The Sizewell C Project

5.5 Two Village Bypass Flood Risk Assessment Addendum Appendices A-D

APPENDIX B: COLLATED COMMENTS FROM THE ENVIRONMENT AGENCY RECEIVED ON 5TH FEBRUARY 2020 AND 4TH AUGUST 2020

Plate 3.21: Difference in maximum flood depth – 1 in 1,000-year event with 35% climate change allowance for additional culvert

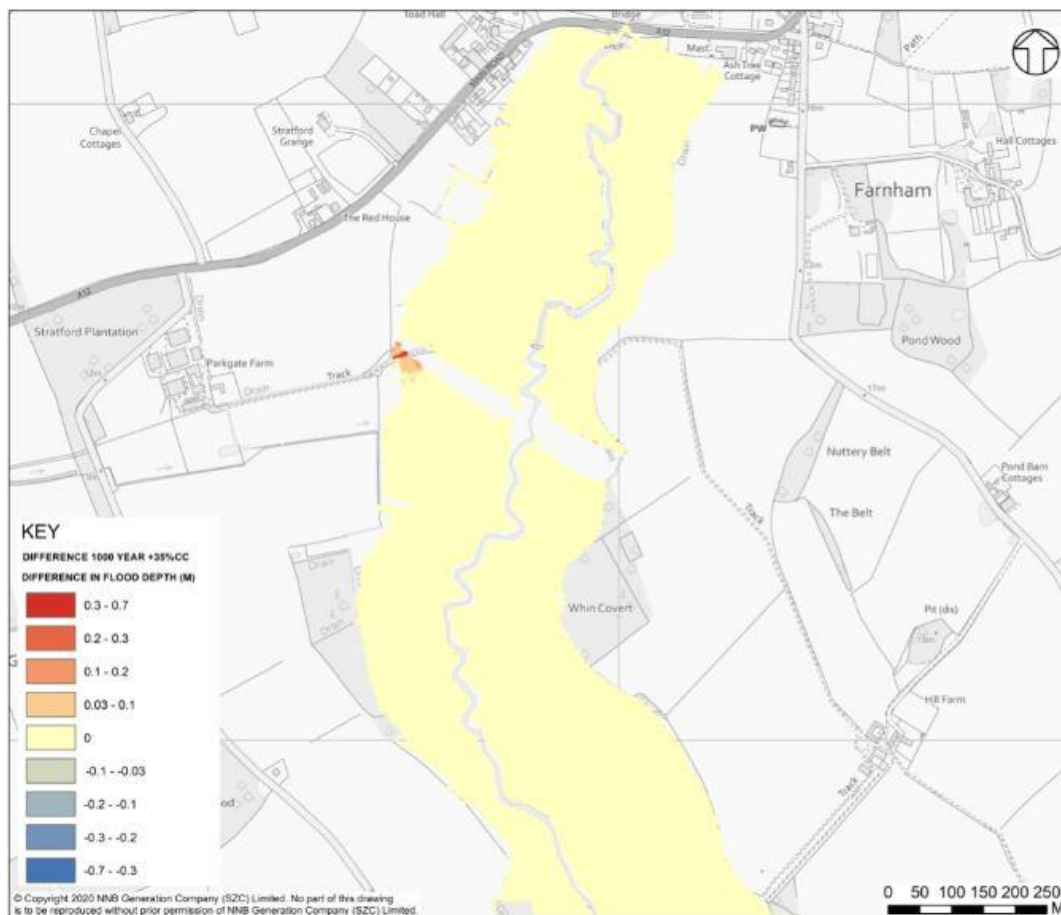
3.7.1 The Environment Agency Comments (comment 3.7 in **Appendix B** of the **Two Village Bypass FRA Addendum**, Doc Ref. 5.5) state that:

3.7.2 For the Application the single portal culvert to the west of the River Alde Crossing (**Plate 3.19** in **section 3.6**) was not represented in the model on the basis that the purpose of the culvert was for a farm access track outside of the 100-year present day baseline flood extent. It was therefore acknowledged that within higher flow scenarios including climate change, where the flood extents and depths are much greater, this culvert may be important in the conveyance of the flood waters.

3.7.3 As the culvert is part of the development, the sensitivity test was run for the with scheme model schematisation only for the 1,000-year plus 35% climate change allowance, where it was expected that the flood extent might reach the culvert. Dimensions of the culvert were adopted the same as the portal culvert over the existing drain on the edge of the eastern floodplain, i.e. 5.4m wide and 3.0m high.

3.7.6 **Plate 3.21** for the with scheme 1,000-year plus 35% climate change scenario, shows significant increases of up to 0.65m in the flood depths only in the particularly localised inlet area of the additional culvert. This is due to local increased flood extent as a result of the culvert passage.

3.7.7 Outside of the additional flood extent, flood depths remained unchanged.
